Re: Alfreda Drive
Stormwater Review

Meyers Engineering, PLLC was requested by Harnett County Development Services to review a storm drainage situation between properties on Alfreda Drive in southwest Harnett County. The following is a summary of the existing situation as I understand it, my research, findings, and my conclusions.

2024 +/- Aerial From Harnett County GIS

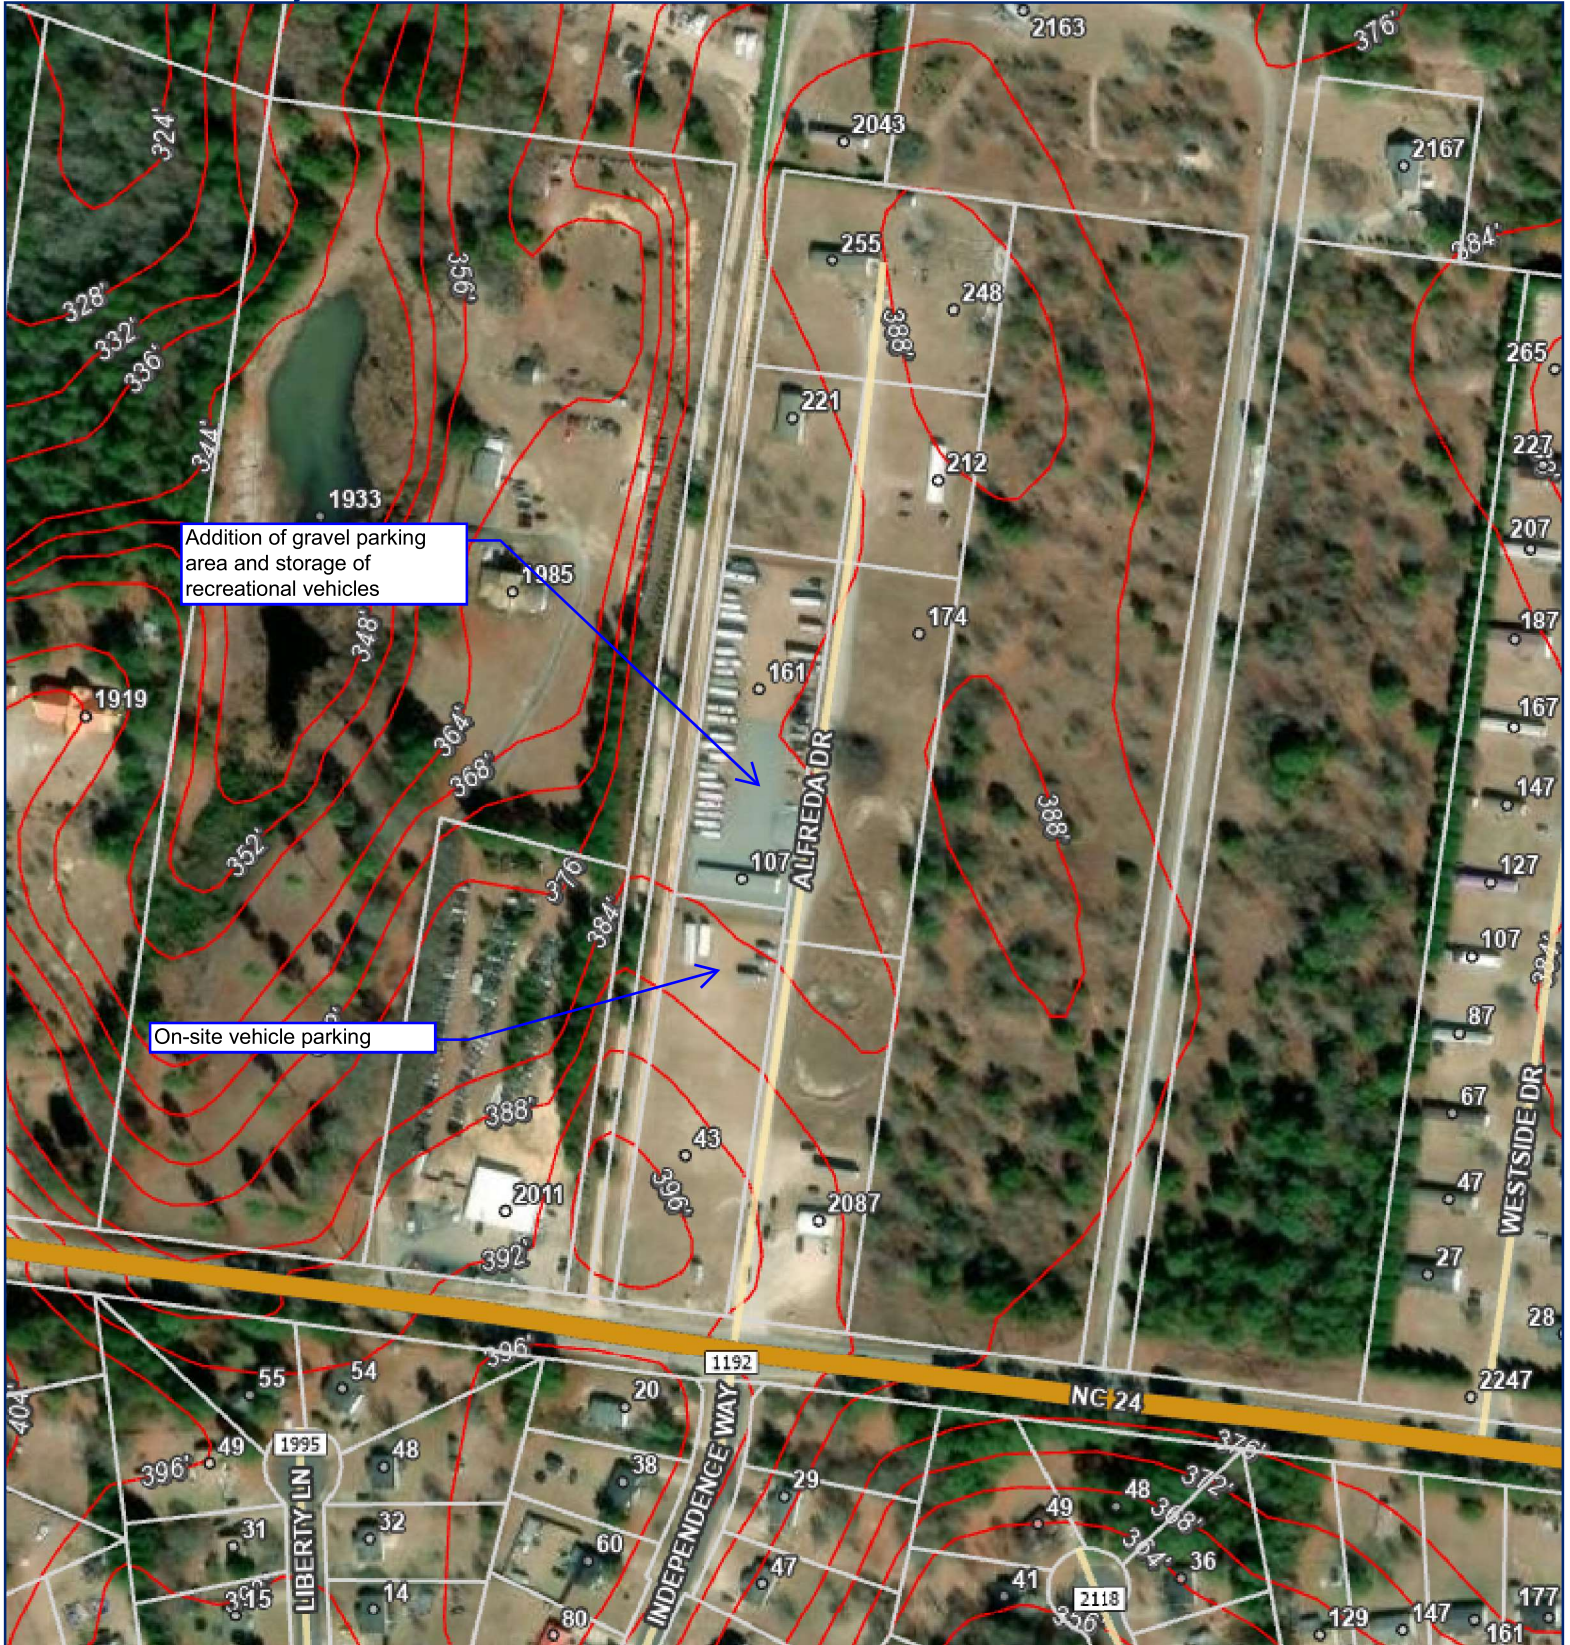
- a. Indicates the addition of gravel parking on the 107 Alfreda property
6. Easy Storage Site Plan by 4D Site Solutions dated August 2023.

Exhibit 6

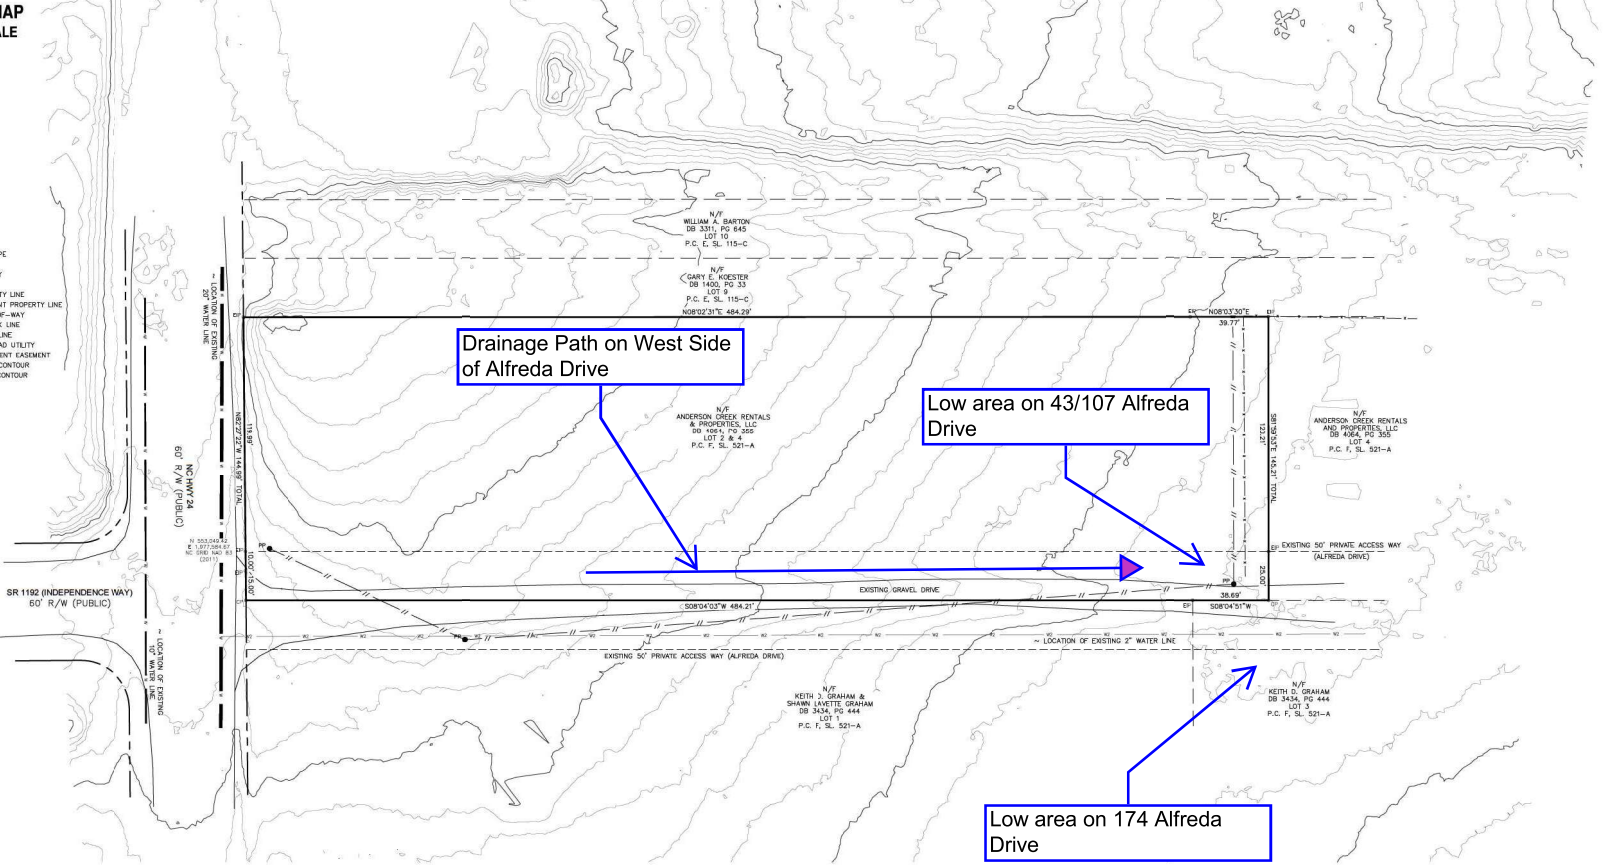
- b. Sheet C-1.0 (Exhibit 6) illustrates existing conditions, including a drainage swale along the western side of Alfreda Drive.
 - c. Sheet C-3.0 (Exhibit 7) doesn't propose any grading to northern half of property nor any changes to Alfreda Drive.

Exhibit 7

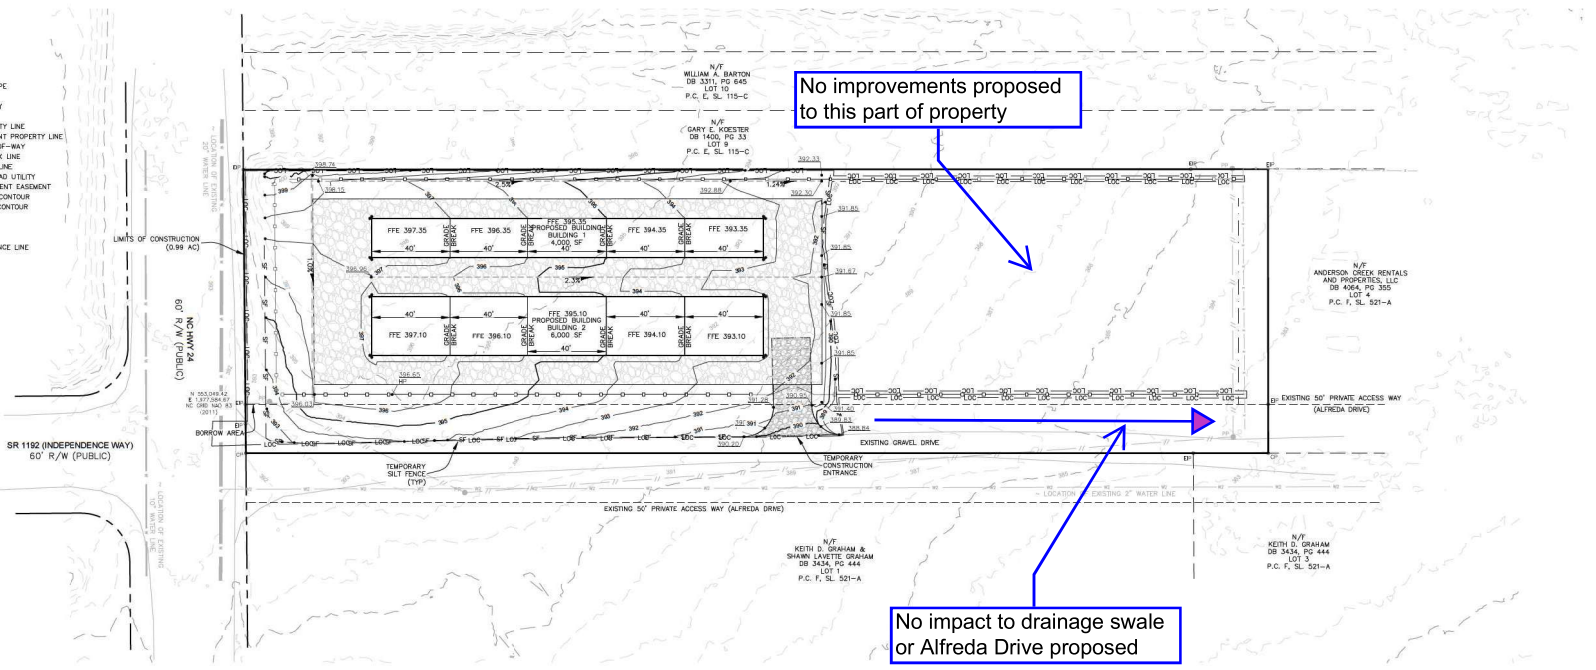
- a. Proposed addition of storage buildings with compacted ABC drive paths around buildings for a total land disturbance of 0.99 acres of the 1.74 acre property. An impact of 1+ acre would trigger requirement for a Soil and Erosion Control plan.
